Responses to FCC questions

Re: FCC ID EW780-5348-00

Correspondence Reference Number : 25368

The following plots show how the transmitter duty cycle is calculated on the 5.8GHz Bundle Cordless Phone.

1.1 Frame Length

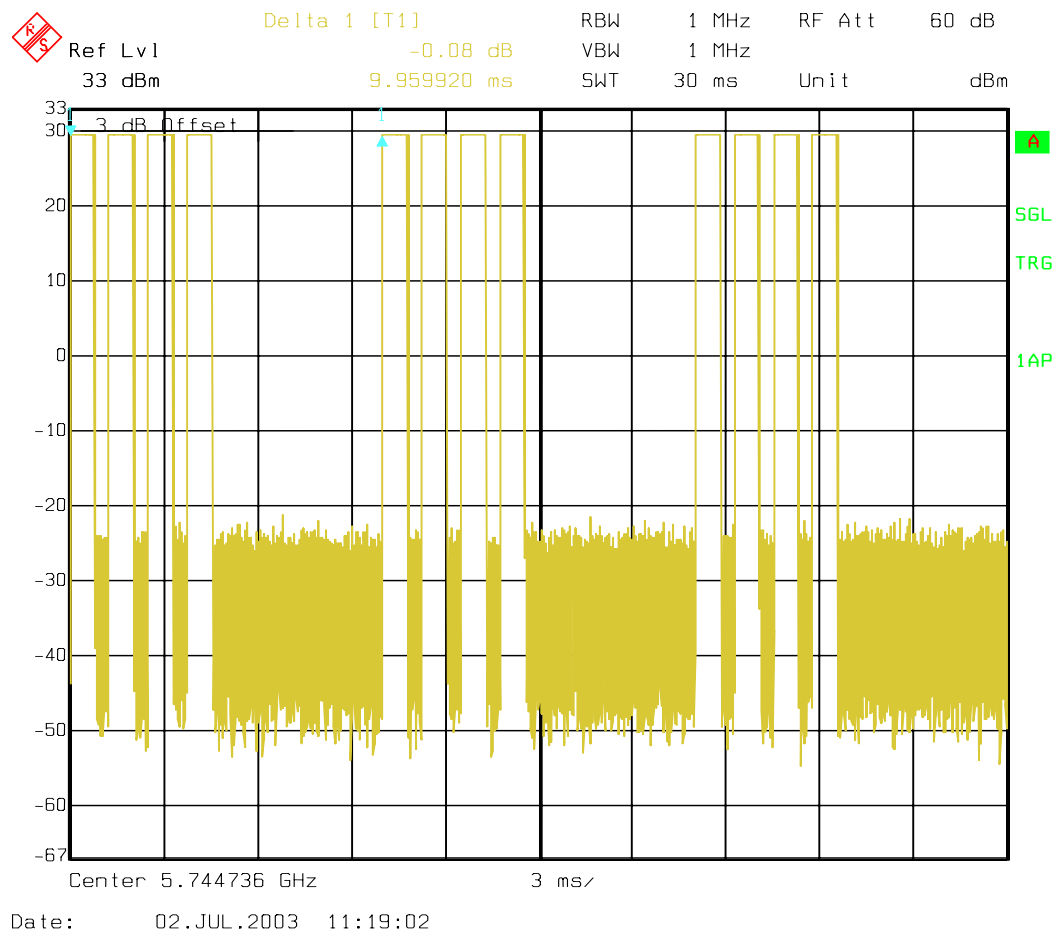
Base Transmit Duty Cycle Calculation for SAR Measurement (Response item 8)

This plot shows the frame length as indicated by the markers: 9.96ms.
